**Committee of Experts on the Transport of Dangerous Goods  
and on the Globally Harmonized System of Classification  
and Labelling of Chemicals**

**Recommendations made by the Sub-Committee at its sixty-second, sixty-third and sixty-fourth sessions and pending issues: Explosives and related matters: Review of tests in parts I, II and III of the MTC**

**Proposed changes to the Koenen test specifications –  
Response to informal document INF.40**

**Transmitted by the experts from Germany, the United Kingdom of  
Great Britain and Northern Ireland, and the United States of America**

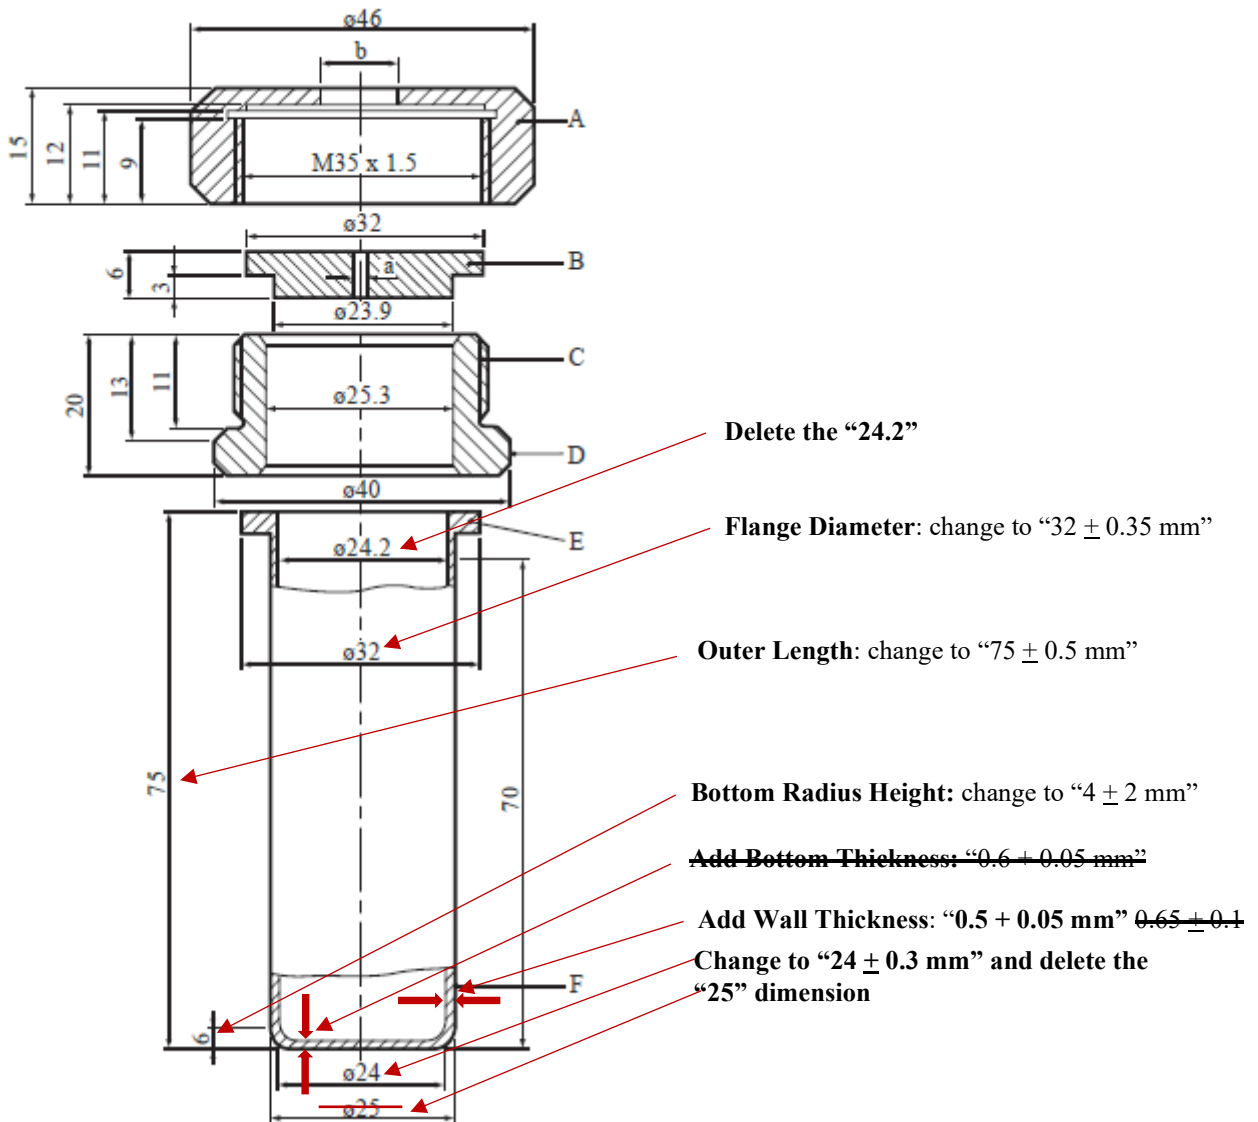
(e) Incorporate the following tube tolerance amendments into Figures 11.5.1.1, 12.5.1.1, 18.6.1.1 and 25.4.1.1. The underlined text is explanatory. Maintain the “key” below the figures.

**Figure A12.2.1: Burst Pressure Apparatus setup**

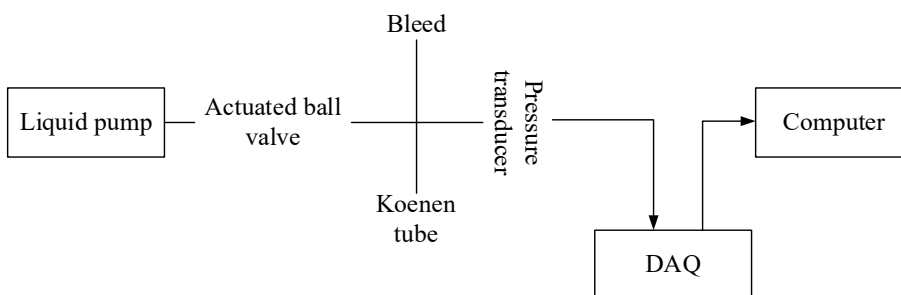
- (a) Burst pressure apparatus (figure A12.2.1) designed to ~~completely purge Koenen tubes of all air and~~ apply pressures of 35 MPa or greater using a non-corrosive liquid, **and optionally capable of purging Koenen tube and apparatus of all air.** The apparatus is equipped to accept a pressure transducer.

- A12.2.3.1 The burst pressure testing apparatus is set up to ~~purge air from the tube and~~ introduce the test liquid. The pressure transducer and data acquisition system are attached (see Figure A12.1) and tested to verify proper functioning and capability to accurately measure and record pressures above the maximum burst pressures specified in 11.5.1.2.1 (d), 12.5.1.2.1 (d), 18.6.1.2.1 (d), or 25.4.1.2.1 (d) of this *Manual*.

- A12.2.3.3 The modified orifice plate is connected to the burst pressure apparatus and placed in a protective area, then connections verified against leaks. **As a best practice it is recommended at this step** that the entire system is purged of air under vacuum, followed by closure of the vacuum valve and examination for constant pressure. The actuated ball-valve is closed to prevent premature pressurization of the Koenen tube, after which the supply line to the closed valve is charged with the pump to approximately 35 MPa. The ball-valve is opened remotely and gauge pressure at which tube bursts is recorded.
